REVIEW OF  
FRENCH LIMITED SITE  
REMEDIAL INVESTIGATION REPORT

Prepared by  
Applied Hydrology Associates

Prepared for  
ARCO Chemicals Company  
and  
The French Limited Task Group

June 5, 1986

Figure 1 - Proposed Well Configuration for Testing Program

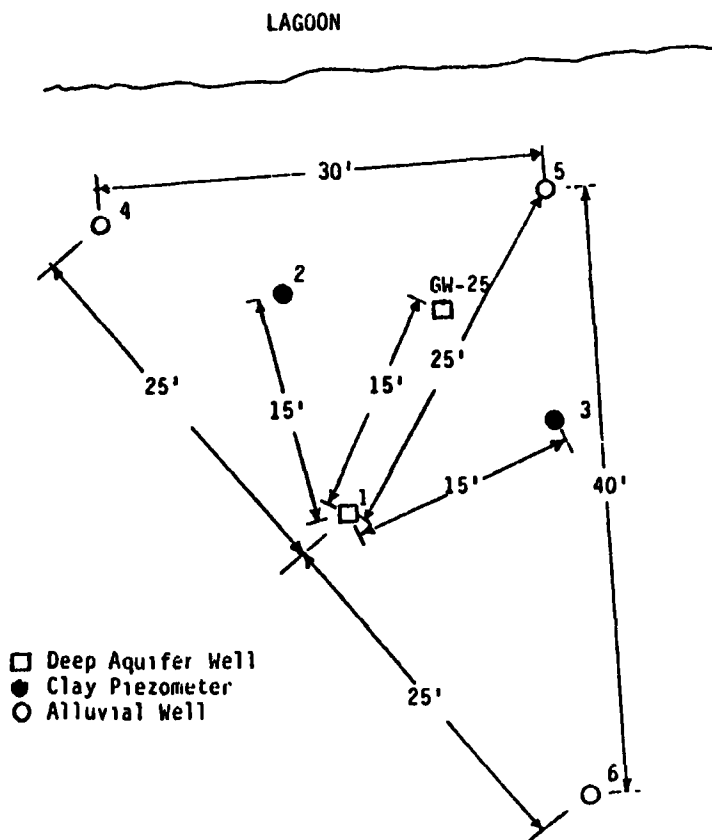
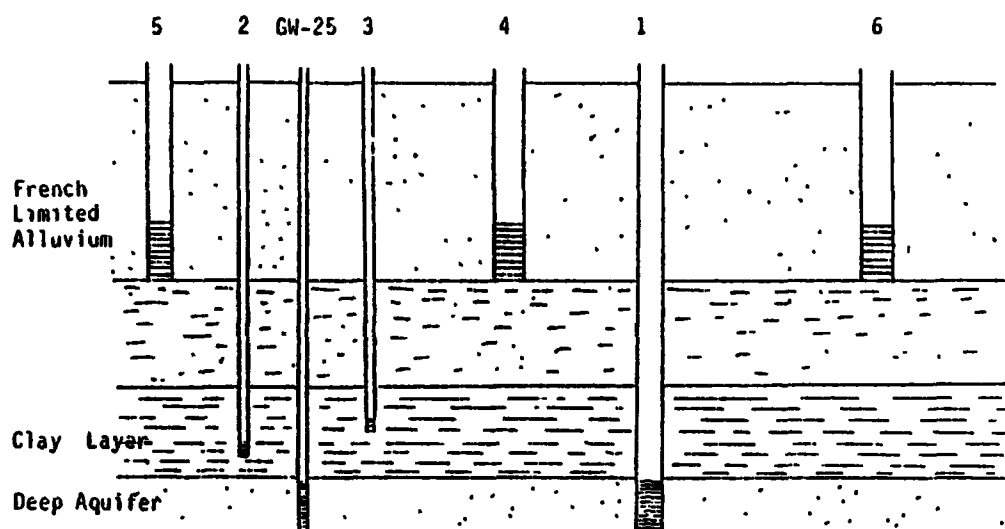
The recommended well layout to perform the program is shown in Figure 1 attached. The layout requires an additional deep aquifer well, three shallow wells completed in the lower part of the French Limited alluvium and two piezometers completed in the lower and central parts of the clay layer.

The new deep aquifer well will be utilized as the pumped well for the deep aquifer test. The well should be completed in a similar fashion to the 3-4 well and located about 15 feet from the GW-25 well. The existing GW-25 well will be used as a monitoring well for the deep aquifer test to allow a more definitive determination of deep aquifer characteristics than was possible at the 3-4 site.

The alluvial wells should be completed with 4 inch diameter casing in a similar fashion as the REI 3-3 well. The location of the alluvial wells in a triangular pattern at varying distances from the GW-25 well as shown in Figure 1 is designed to evaluate the contention that the well may be a conduit for contaminant migration to the deep aquifer. Static water level elevations in the three wells may reveal a hydraulic gradient towards the GW-25 well if significant leakage is taking place at this location. This process may also be revealed by the relative response of the three wells (if any) during the deep aquifer test. If the three wells show responses during the deep well test that are essentially the same then this would be indicative of a more uniform communication across the clay layer. During the deep aquifer test, it is recommended that packers should be set on one inch diameter pipe above the screened intervals of the alluvial wells so that water level responses will be more sensitive.

The clay piezometers should be completed using 1-2inch ID pipe through surface casing using similar techniques as recommended for the deep aquifer well. The lower sections of the piezometer holes should preferably be drilled using auger or air-rotary techniques. Screened and sand-packed intervals for the piezometers should be about 2 feet in length.
